Drain-Improvement: Canal Place Section 1

Re: Canal Place Drain, Section 1 Arm

Re: Canal Place Drain: Section 1 Arm

Map Correction-Field Verification

CANAL PLACE SEC. 1

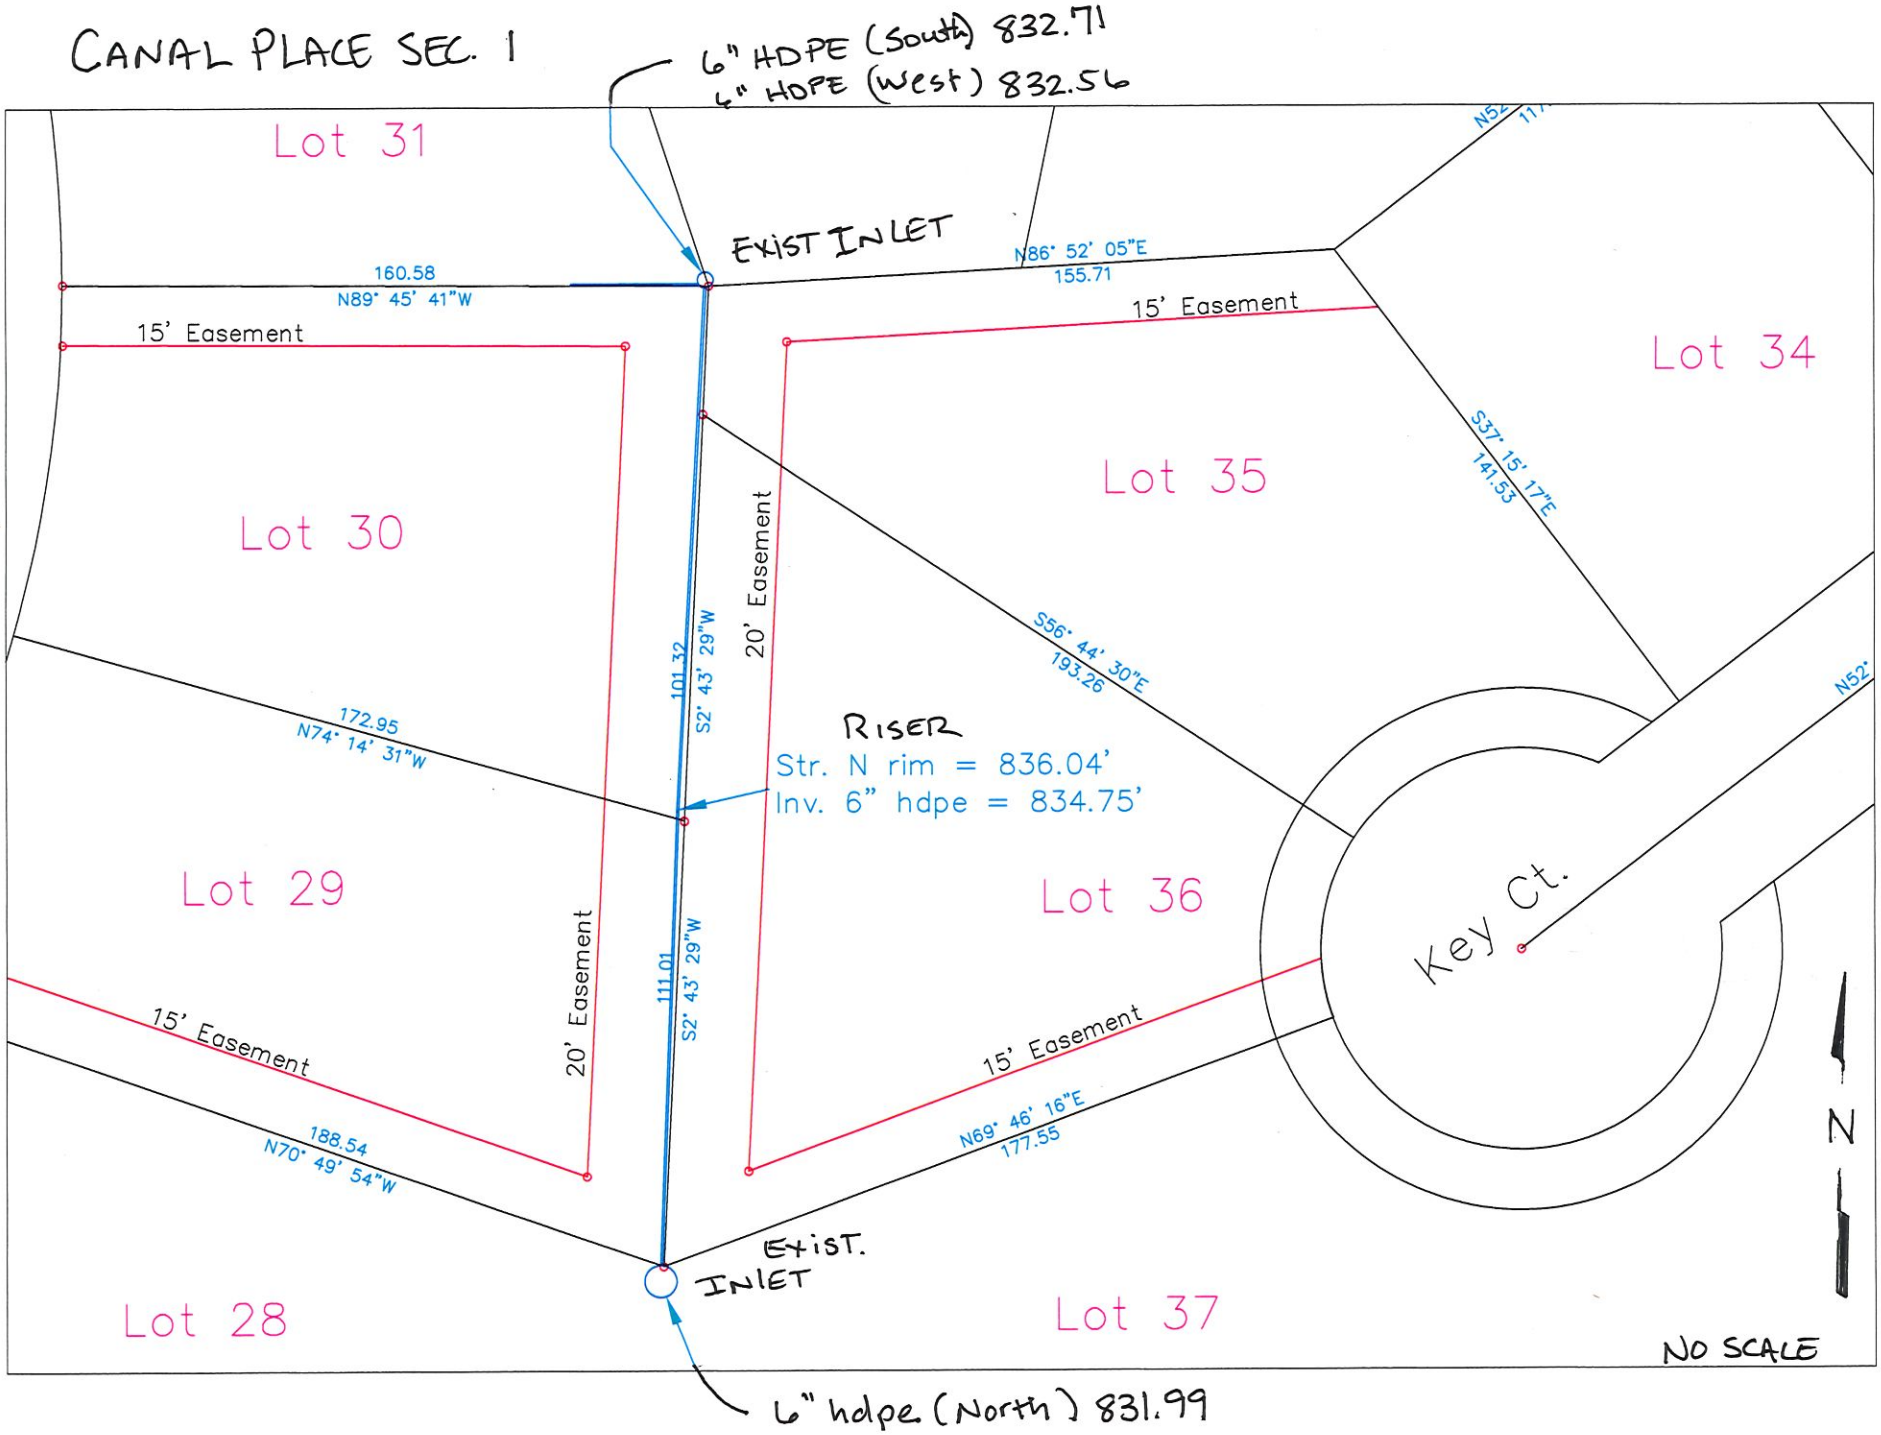
WO-2016-00260 added 6"SSD across rear of lots 29-30. Riser was also set. Project was surveyed by Brian Rayl.
